Product Change Notification / ASER-24QQEH990

CCB 4753 Final Notice: Qualification of STA as an additional assembly site for selected LAN8710Axxx device family available in 32L VQFN (5x5x0.9mm) package.

Pre and Post Change Summary

Lead Frame Comparison Comparison

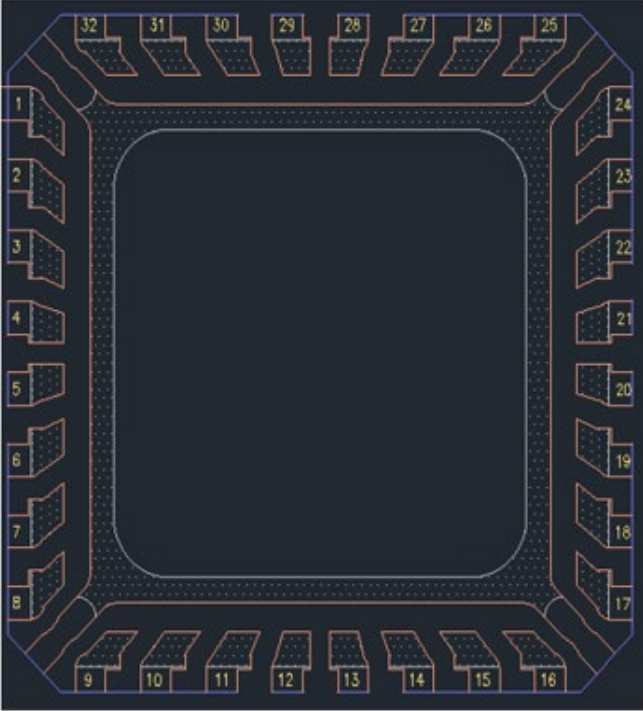
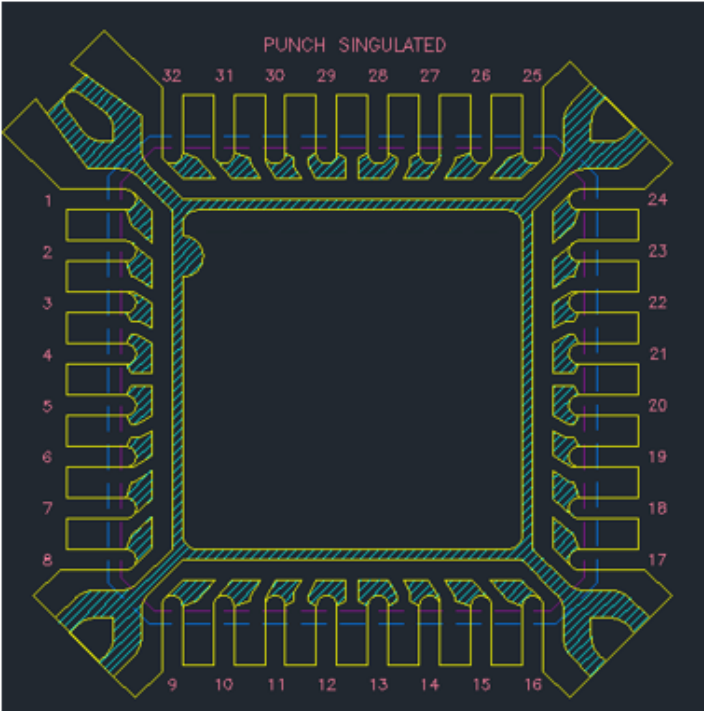
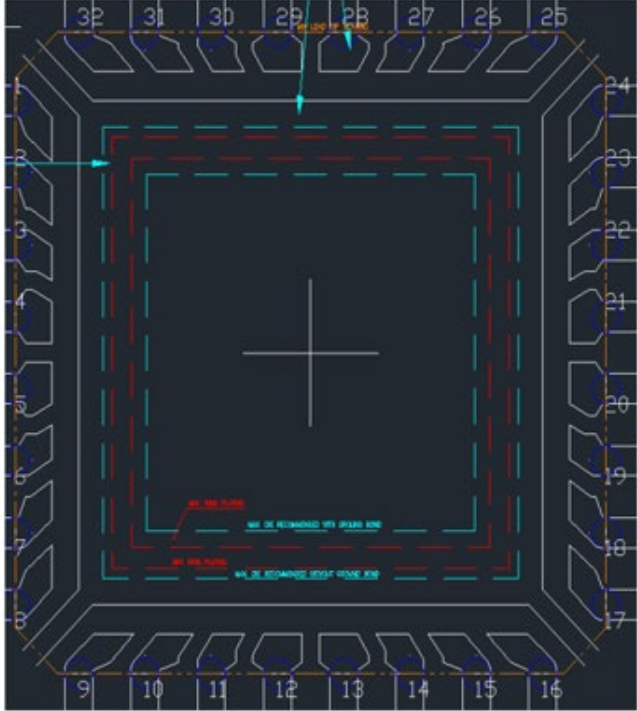
Description of Change:Qualification of STA as an additional assembly site for selected LAN8710Axxx device family available in 32L VQFN (5x5x0.9mm) package.

Wire material	CuPd	CuPd	CuPd	CuPd	CuPdAu
Die attach material	EN-4900F	8290	EN-4900F	8290	Ablebond 8290
Molding compound material	G631B	G700	G631B	G700	G700E
DAP Surface Prep	Double Ring Plating	Ag Double Ring	Double Ring Plating	Ag Double Ring	Ring Plating
Lead frame material	C194	C194	C194	C194	C194
Lead-lock (with locking holes)	No	Yes	No	Yes	No
	See Pre and Post Change Summary for comparison.
